WORK ORDER NON-CONFORMANCE / UPDATE

Item ID: D2731-3RG Accept ***N900040100*** Setup Start ***NS1***
Revision ID: Stop ***NS2***
Item Name: Mounting Lug
Start Date: 1/21/2016 Start Qty: 8.00 ***8*** Cust Item ID:
Required Date: 1/21/2016 Req'd Qty: 8.00 ***8*** Customer:
Reference:

DRAWING NO. D2731	TITLE MOUNTING LUG	REV. C	DART AEROSPACE USA, INC ENGINEERING ORDER		D.E.O. NO. D2731-C-1	SHEET NO. SHEET 1 OF 1	SCALE NTS
DRAWN <i>q</i>	CHECKED <i>sc</i>	MFG. APPR. <i>MA</i>	APPROVED <i>MD</i>		DE APPR. <i>MD</i>		
DATE 11.05.02	DATE 11.05.09	DATE 11.05.09	DATE 11.05.09		DATE 11.05.09

ADD D2731-xRG OPTION

SECTION B-B D4-3
SCALE 2X
R0.06 MIN-R0.10 MAX. C

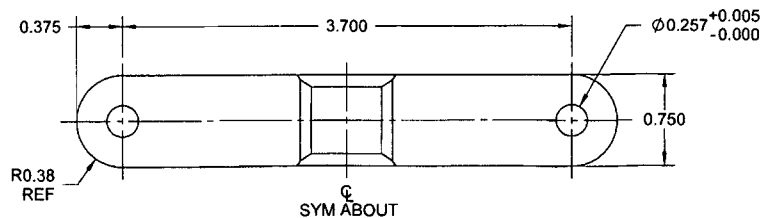
C	REDRAWN IN SOLIDWORKS TO CURRENT DESIGN STANDARDS. REFER TO SECTION A-A, B-B, C-C & D-D FILLET ADDED TO PREVENT CHAFING OF RUBBER CUSHION ON INSTALLATION.	AJS	09.01.19
B	REVISED DIMENSIONS	KE	99.07.06
A	NEW ISSUE	KE	98.05.13
REV.	DESCRIPTION	BY	DATE
DESIGN	KE	DART AEROSPACE USA, INC. PORT HADLOCK, WA	
DRAWN	AJS		
CHECKED		DRAWING NO.	REV. C
MFG. APPR.		D2731	SHEET 1 OF 5
APPROVED		TITLE	SCALE
DE APPR.		MOUNTING LUG	NTS
DATE	09.01.19	COPYRIGHT © 1998 BY DART AEROSPACE USA, INC. THIS DOCUMENT IS PRIVATE AND CONFIDENTIAL AND IS SUPPLIED ON THE EXPRESS CONDITION THAT IT IS NOT TO BE USED FOR ANY PURPOSE OR COPIED OR REPRODUCED TO ANY OTHER PERSON WITHOUT WRITTEN PERMISSION FROM DART AEROSPACE USA, INC.

D2731-1RG MOUNTING LUG (SHOWN)
D2731-3RG/-5RG/-7RG MOUNTING LUGS (SIMILAR)

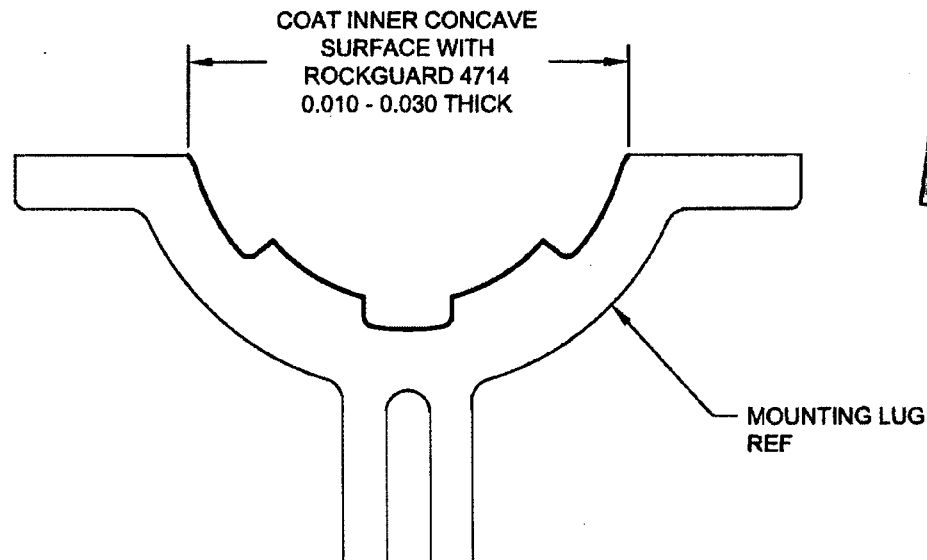
D2731-xRG MOUNTING LUGS ARE INDENTICAL TO D2731-x MOUNTING LUGS, HOWEVER AFTER FINISH, COAT INNER CONCAVE SURFACE WITH "PLUS ONE ROCKGUARD 4714" AS SHOWN BELOW.
